Re: Former Chevron Station #9-1026
3701 Broadway
Oakland, California

May 22, 1990

Re: Former Chevron SS #91026
3701 Broadway
Oakland, California
WA Job #4-418-00

Figure 2. Proposed and Existing Monitoring Well Locations - Former Chevron Service Station #91026, 3701 Broadway, Oakland, California

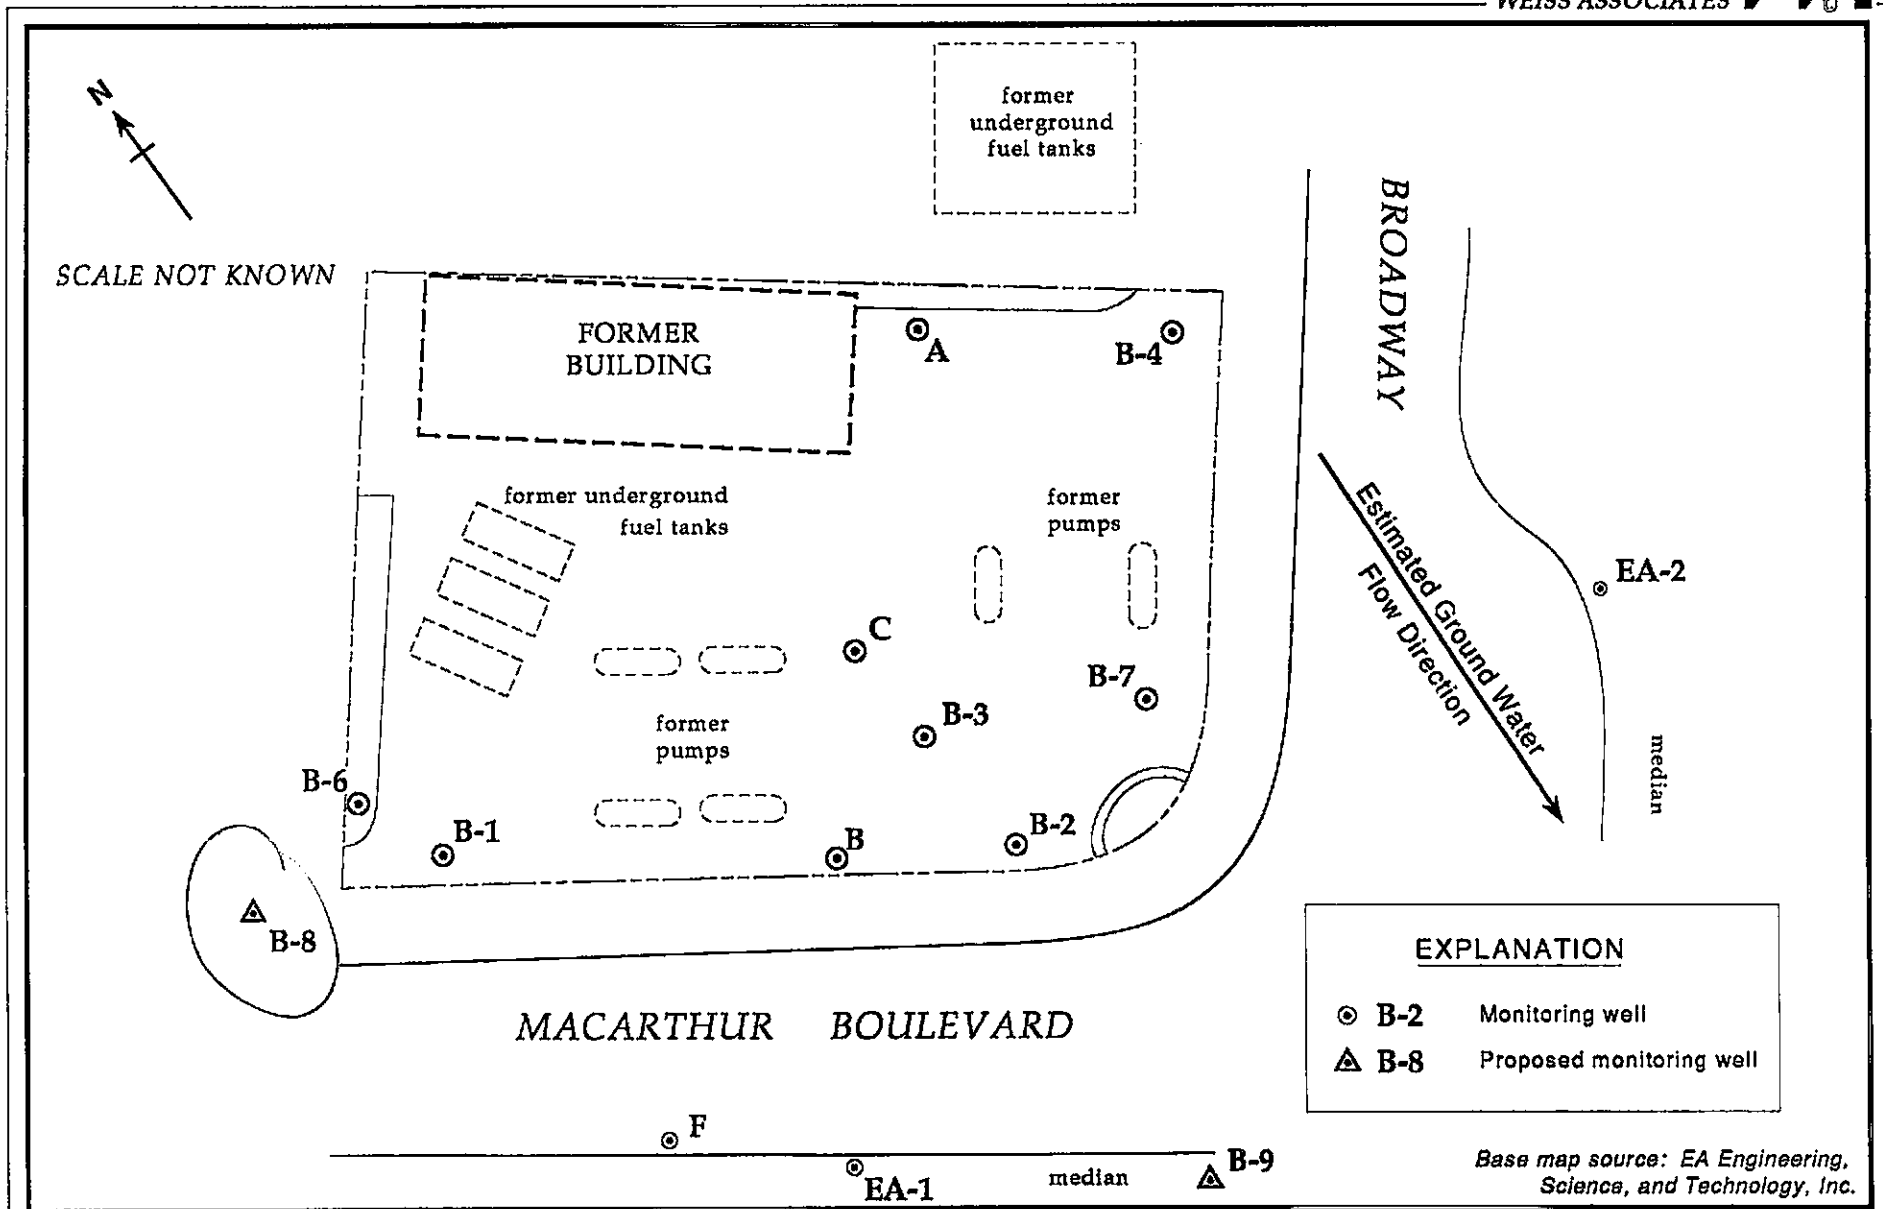
The March 13, 1990 quarterly monitoring report was forwarded by Chevron to the Alameda County Department of Environmental Health, Hazardous Materials Division (the Division). The report was reviewed by Mr. Gil Wistar, Hazardous Materials Specialist for the Division. In a letter dated May 9, 1990, Mr. Wistar wrote to Chevron approving abandonment of wells B, B-6 and B-7 (Figure 2) according to local regulatory guidelines. However, the Division requested replacing well B-6, since it defines the northernmost edge of the groundwater monitoring system at the site.

The Division also noted that hydrocarbon concentrations in ground water from upgradient wells A and B-4 are increasing over the past year. Therefore, they require installing at least one additional monitoring well further upgradient of these wells, and at the northern corner of the property, northwest of the former station building. However, WA has learned that 3 underground fuel storage tanks were located about 15 ft northeast of wells A and B-4. These tanks were removed about 3 years ago from the adjacent former Rainbow Car Wash facility now occupied by a new car dealership². We also learned that the tanks were removed by R.J. Miller Co., of Richmond, California. Although no records of the tank removal are on

WA will drill one or two soil borings in the locations shown on Figure 2 to assess the presence or absence of hydrocarbons in subsurface materials. Actual soil boring location(s) may differ from those shown on Figure 2, based on access and field conditions, such as overhead and underground utilities. Based on existing ground water conditions at the site, we anticipate ground water is less than 20 ft below grade.
